ACCESSION NBR: 8807010691      DOC. DATE: 88/06/23      NOTARIZED: NO      DOCKET #  
 FACIL: 50-335 St. Lucie Plant, Unit 1, Florida Power & Light Co.      05000335  
       50-389 St. Lucie Plant, Unit 2, Florida Power & Light Co.      05000389  
 AUTH. NAME      AUTHOR AFFILIATION  
 CONWAY, W. F.      Florida Power & Light Co.  
 RECIP. NAME      RECIPIENT AFFILIATION  
 STELLO, V.      Ofc of the Executive Director for Operations

SUBJECT: Responds to Questions 471.5 - 471.12 re App A exemption request for worker respiratory protection apparatus.

Re: St. Lucie Units 1 and 2  
Docket Nos. 50-335 and 50-389  
Request for Additional Information - 10 CFR 20  
Appendix A Exemption Request for Worker Respiratory  
Protection Apparatus (TAC Nos. 67138 and 67139)

FIGURE 1  
SCOTT 631-TEDA-H CANISTER

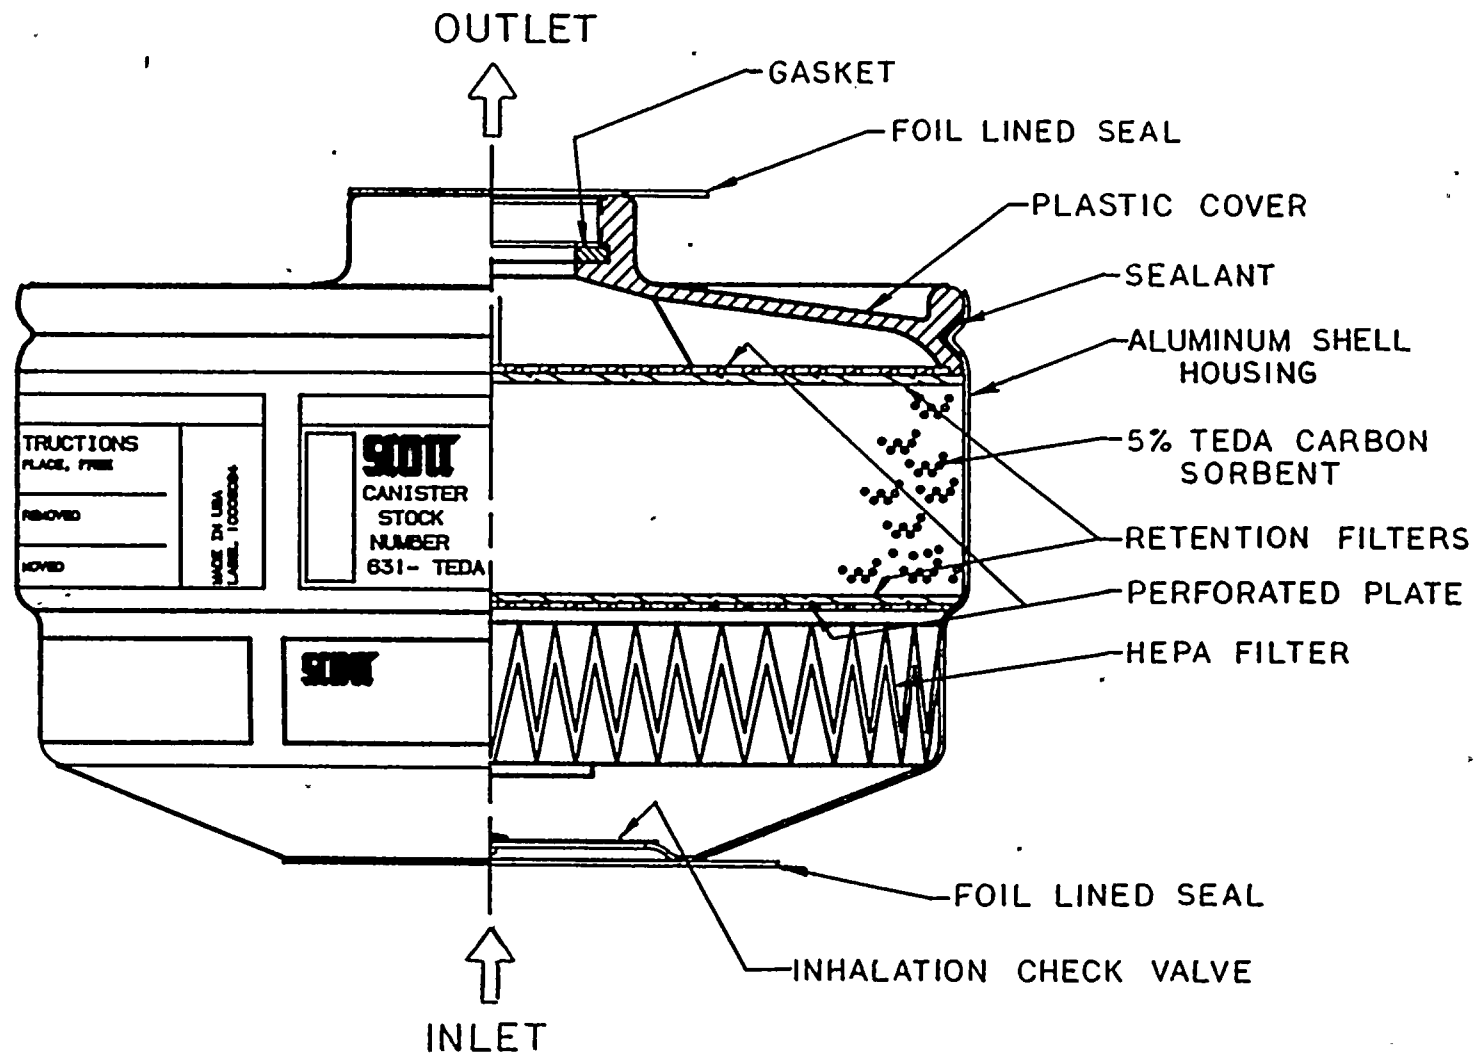
Provide a description of the SCOTT 631-TEDA-H canister including particulate filter, sorbent and percent TEDA. Address the question of the potential toxic hazard to the respirator user from inhalation of TEDA desorbed from the SCOTT 631-TEDA-H canister. Describe the criteria for use of these SCOTT canisters at St. Lucie (e.g., radioiodine concentration, canister labeling, prevention of canister reuse).

The 631-TEDA-H chin style gas mask canister is constructed using a 12 x 20 mesh (U. S. Sieve series) activated carbon, impregnated with 5% by weight triethylenediamine (TEDA), and a high efficiency particulate air (HEPA) filter. Figure 1, attached, depicts the canister construction.

The sorbent in the canister is batch certified to meet the ASTM D3803 and D4069 radioiodine performance requirements. The volume it occupies within the canister is 340 cc's.

The HEPA filter is a radially pleated high efficiency filter with greater than 99.97% removal efficiency against a 0.3 micrometer dioctylphthalate (DOP) aerosol. Canisters are 100% tested for DOP removal efficiency at the time of manufacture per NIOSH respirator certification requirements of 30 CFR Part 11.

METHYL IODIDE TEST SYSTEM

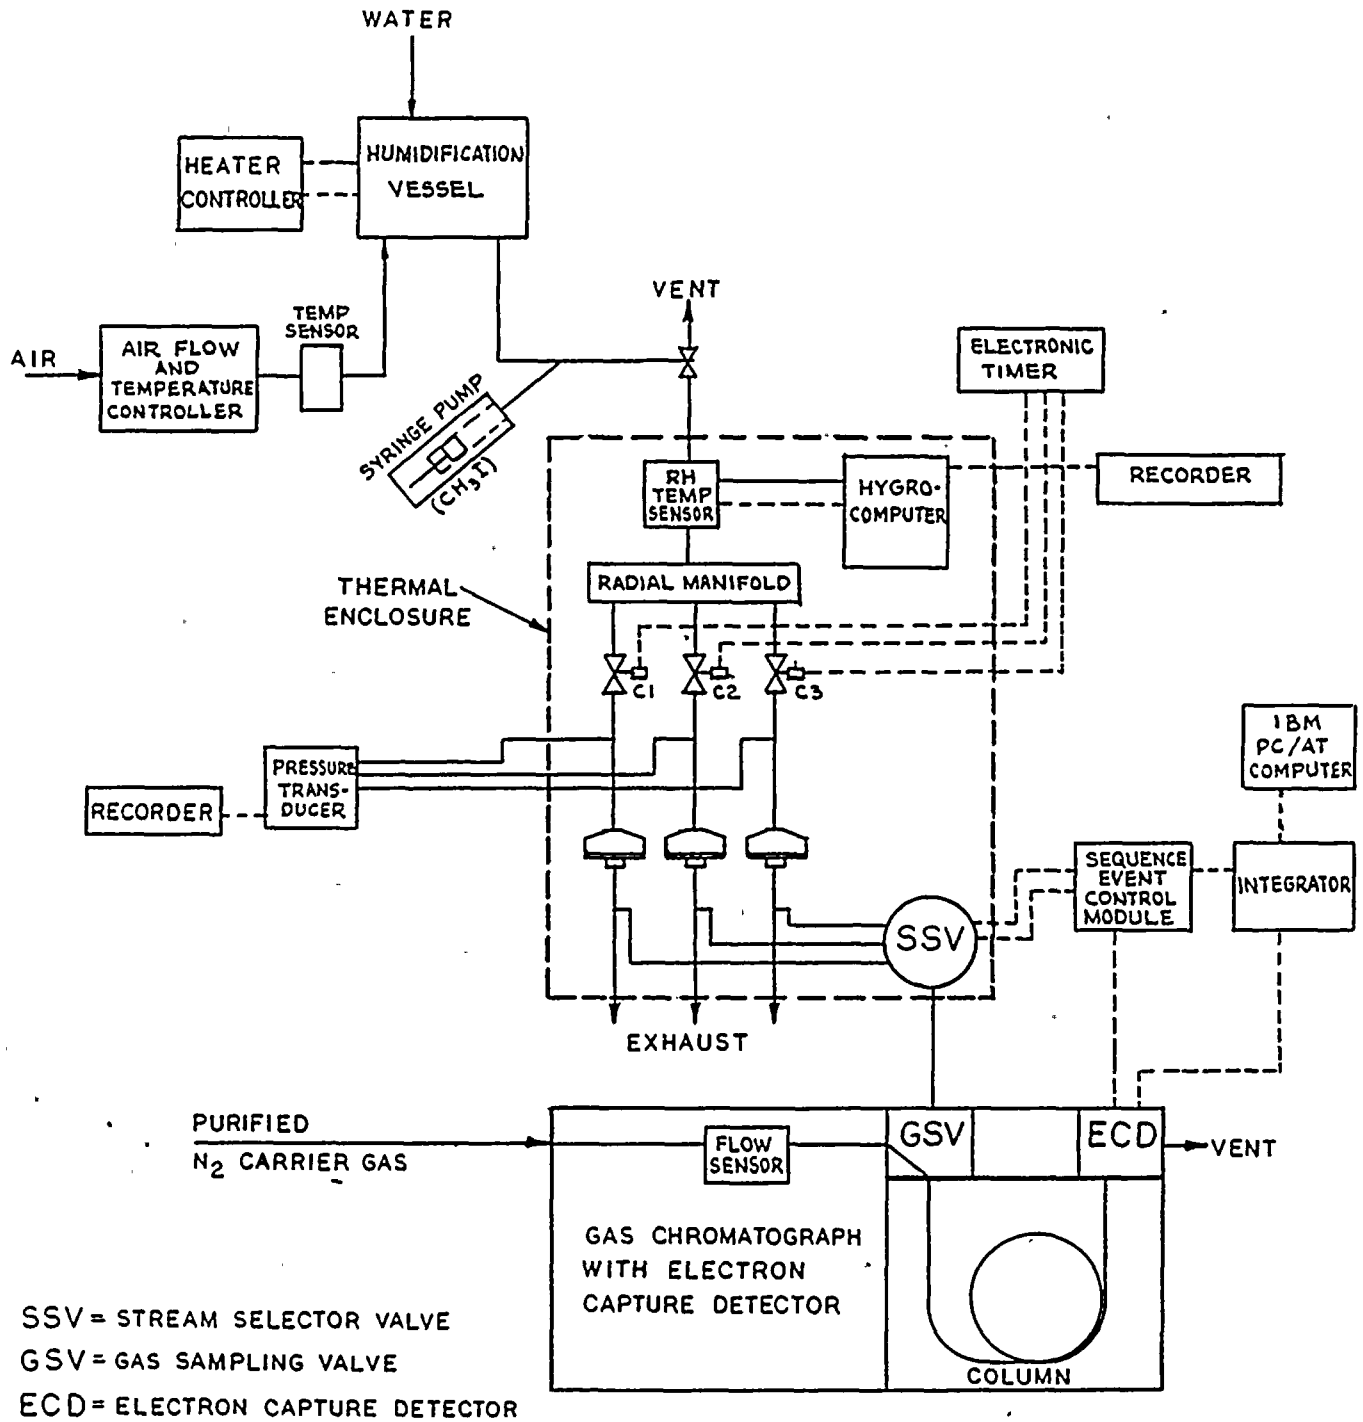
The FPL submittal includes tabular summaries of test conditions and test results provided by SCOTT for the SCOTT 631-TEDA-H canister but contains no other information on these tests or on the means for ensuring the reliability of the tests and test results. Provide a complete description and discussion of the test program (including apparatus used), the means for ensuring the reliability of the tests and the test results, and the basis for your acceptance of the test results. Include the complete name and address of the manufacturer (SCOTT) and the identification of the organization or group that actually performed the tests, if other than SCOTT.

A sketch depicting the test system used to determine the performance of the SCOTT 631-TEDA-H canisters against methyl iodide is shown in Figure 2. The primary

RELATIVE HUMIDITY vs. BREAKTHROUGH TIME FOR  
THE SCOTT 631-TEDA-H CHIN CANISTER

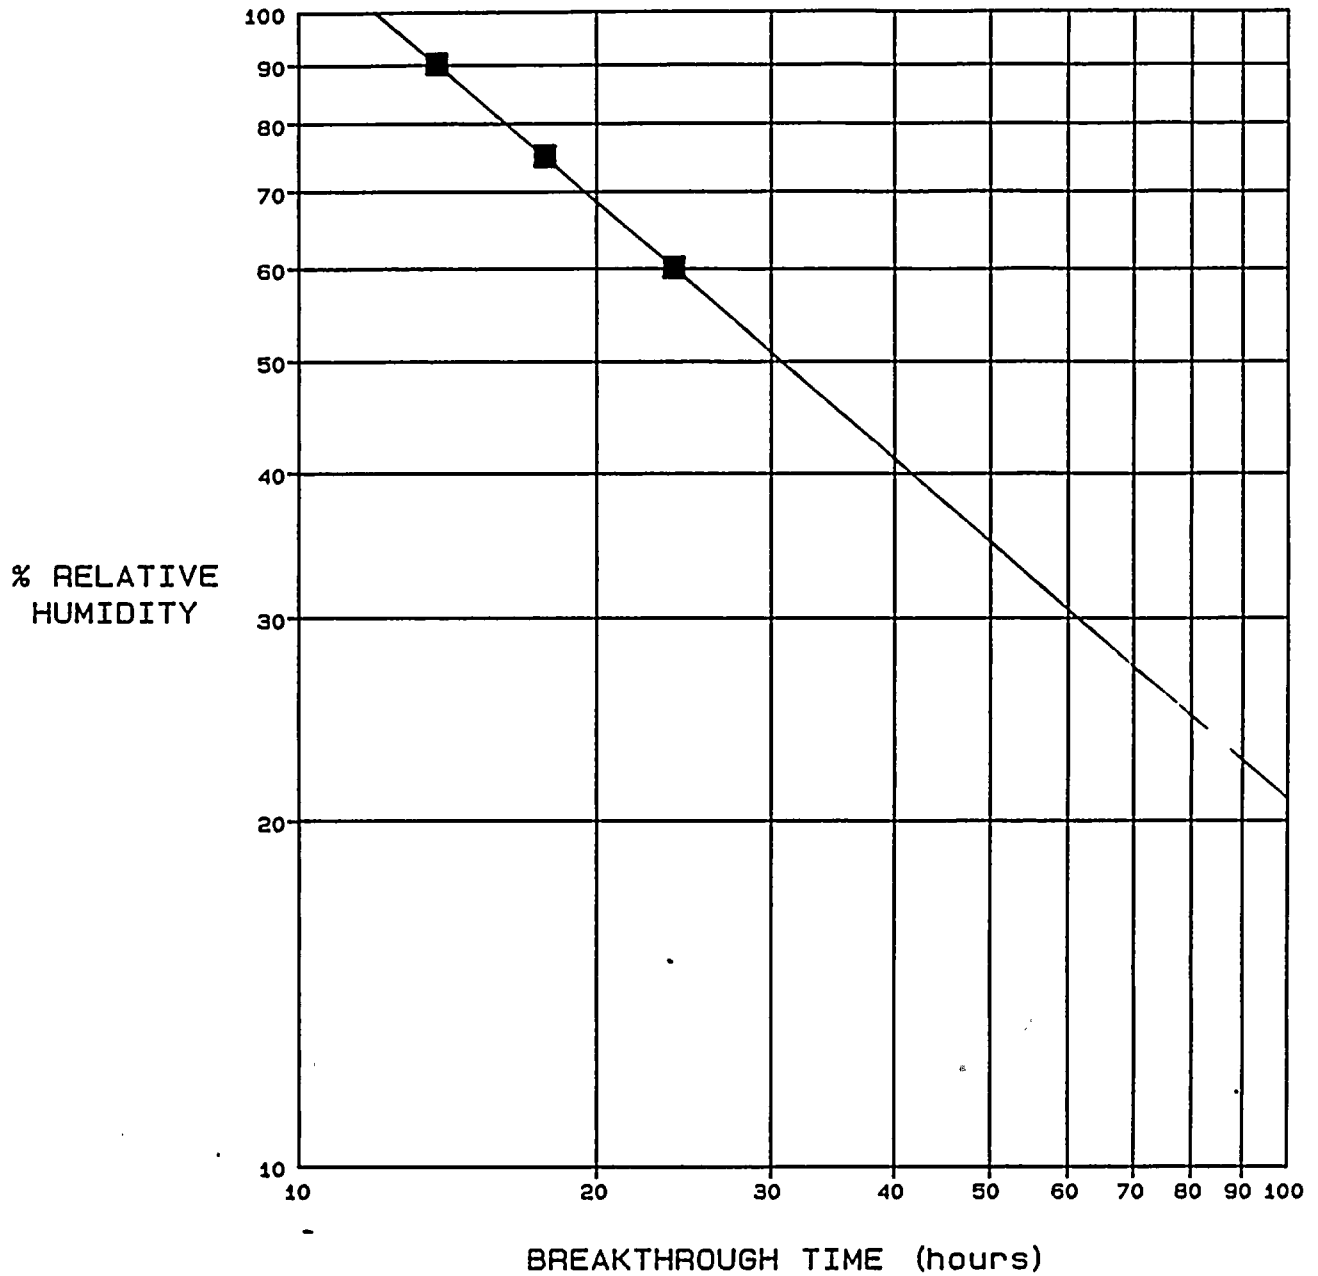
The FPL submittal states that the SCOTT canisters are not to be used in environments greater than 120°F but does not provide a limit on the relative humidity. Specify a limit on the relative humidity for canister use and provide the basis for this limit. Specify how compliance with the limits for temperature and humidity will be demonstrated.

The performance of the 631-TEDA-H canister has been characterized at various conditions which include 37.8°C/48.9°C temperatures and 60/90% relative humidity. The ability to extrapolate test results from one set of humidity conditions to another humidity level has been demonstrated (3). Using data at the 48.9°C temperature, a log-log plot of breakthrough time vs. % relative humidity has been prepared and is shown in Figure 3. Using a linear extrapolation, canister service life to a 1% methyl iodide penetration value is projected to be 12.0 hours.

at 48.9°C (120°F) should provide a nominal 12 hour duration to a 1% methyl iodide penetration.
